State of West Virginia **Purchase Order**

Order Number:	CPO 0310 6377 DNR2000000012 9	Procurement Folder:	697731	
Document Name: Bowden Hatchery 3 - New Facilities Construction		Reason for Modification:		
Document Description:	Change Order No. 06- Bowden Hatchery 3- New Facilities Const	Change Order No. 06 to extend and inc contract per the attached documentation		
Procurement Type:	Central Purchase Order			
Buyer Name:	Joseph E Hager III			
Telephone:	(304) 558-2306			
Email:	joseph.e.hageriii@wv.gov			
Shipping Method:	Best Way	Effective Start Date:	2020-08-31	
Free on Board:	FOB Dest, Freight Prepaid	Effective End Date:	2023-02-28

Change Order

Bowden Hatchery Improvements Contract 3 Attachment to Change Order 6

COP 36 Sketch KCS 12/2/21

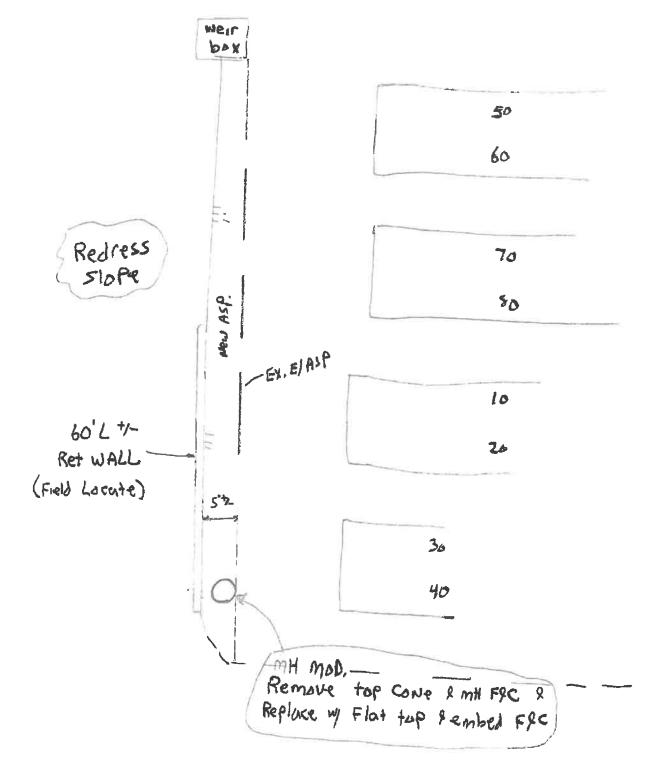
Revised Change Order Proposal 36-r1: Add Ret wall at west end of raceways

As requested at last weeks project meeting, we are pleased to provide the following revised change order proposal (including backup material & subcontactor documents) to add a 60-foot long (2'w x 2'h) bin block wall x 2 courses high along the west side of the existing raceways, make modifications to the existing manhole (remove top cone & mh frame & cover and replace with flat top & embedded mh frame & cover), redress & seed and mulch slope between weir box & manhole modif, and add asphalt (see attached sketch for more info)

We propose to perform the above work for the lump sum price of \$57,700.00 (Fifty Seven Thousand Seven Hundred dollars) (Please see attached breakdown for more information).

Change Order Proposal 45-r1: Add Chainlink fence at Plant Site

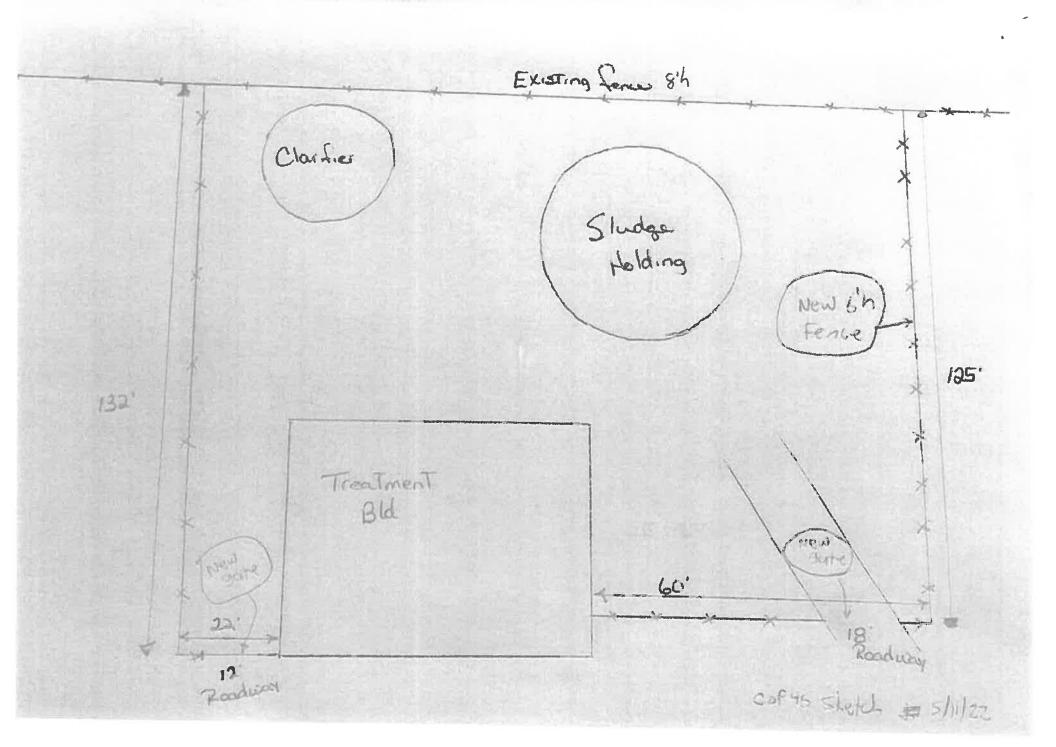
As requested at last weeks project meeting, we are pleased to provide the following revised change order proposal (including backup material & subcontactor documents) to provide the following change order proposal to furnish and install 6ft high chainlink fence (with no barbwire), 1 ea - 12ft wide double gate and 1 ea - 18ft wide double gate at the plant site (see attached sketch for more info)
